**EAST THAME RESIDENTS ASSOCIATION TO:**

**Addendum to the Transport Assessment**

**Reference: P20/S2593/O**

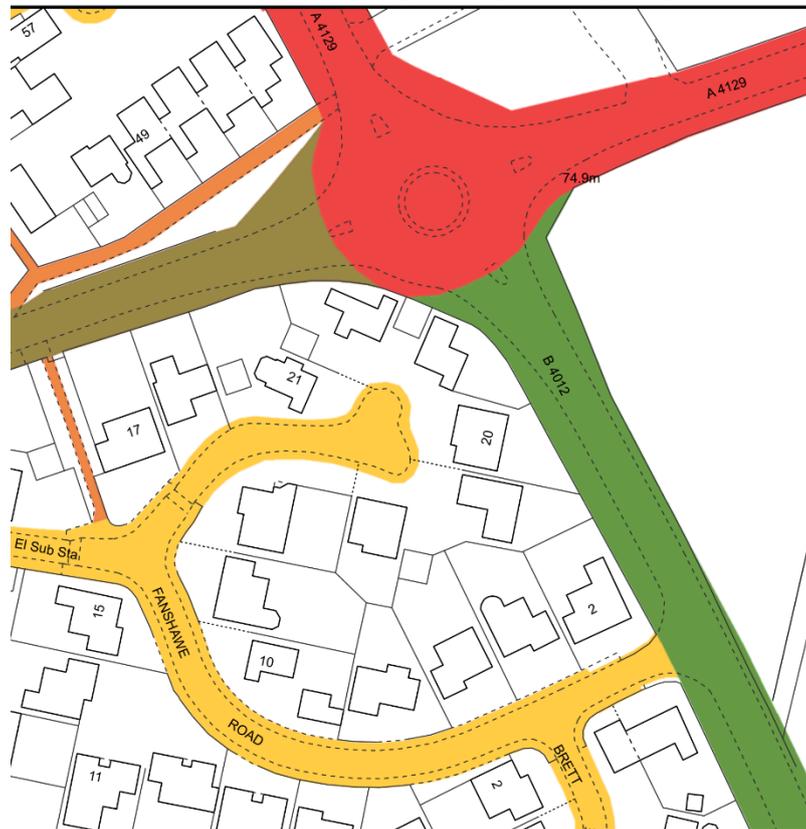
The most appropriate way to provide pedestrian connectivity to link the to the existing footways from the site to Fanshawe Road, Griffin Road, Whittle Road, Pickenfield, Pearce Way and beyond to the new homes off Wenman Way would be **to provide a footway / cycleway from the existing footway that ends between Pickenfield and Towersey Drive on Howland Road, all the way to a new puffin crossing to the site.** This would complete the route to the Phoenix Trail, as a cycling and walking link to many residential areas beyond, and importantly to the west, which is strangely not mentioned in this report.

Queens Road does not have a footway on the last section before its junction with Kingsey Road, and it is difficult to see if this could be achieved. This means that to complete the journey on foot from Queens Road, Croft Road, Chinnor Road it is necessary to cross into Seven Acres to cut through to Kingsey Road. A safer zebra crossing is needed on Kingsey Road to cross over to the footway from Churchill Crescent eastwards to the site This is currently served by a lollipop person at school start and finish times, but this is likely to become busier at other times if Kingsey Road is the main walking route to the medical centre. This would have the added benefit of serving school children from the Lea Park area to safely cross toward the Lower School.
